ENGINEERING ORDER

1. ENGINEERING ORDER NO. 2014A0237-T

2. DWG TITLE: ACTUATOR ASSEMBLY - ESCAPE SPOILER		3. DWG CAGE CODE: 81205	4. DWG NO.: 5-84042
5. NEXT ASSY: 50-1574	6. USED ON: KC-135	7. OPR CAGE CODE: 98748	DWG SIZE: J; DWG SHEET(S): 1; LATEST DWG REV LTR: D

REVISE DRAWING 5-84042-2 SHEET 1 - ZONE C6 AS SHOWN TO ADD UID LABEL ON SURFACE

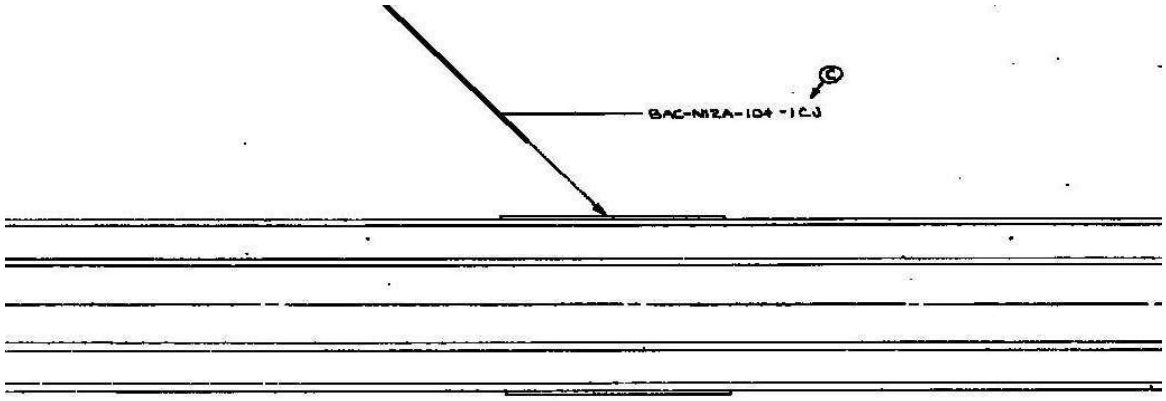
ADD 200831032-121 (USE MIL-I-46058C TYPE UR
CONFORMAL COATING (1A20, 1A33, OR EQUIV)
TO OVERCOAT LABEL)

- New and repaired Actuator assemblies 5-84042-2 shall be marked with a Unique Item Identifier (UII). (REF: MIL-STD-130)

- If no UID label is present, fabricate new UID label (200831032-121) to attach to the end item, located as shown on Page 2.

- After attaching IUID plate to end item, apply a thin overcoat to IUID plate ensuring the plate edges are sealed, using 1A20, 1A33 or equivalent Polyurethane Conformal Coating, per manufacturer's instructions. REF: MIL-I-46058C.
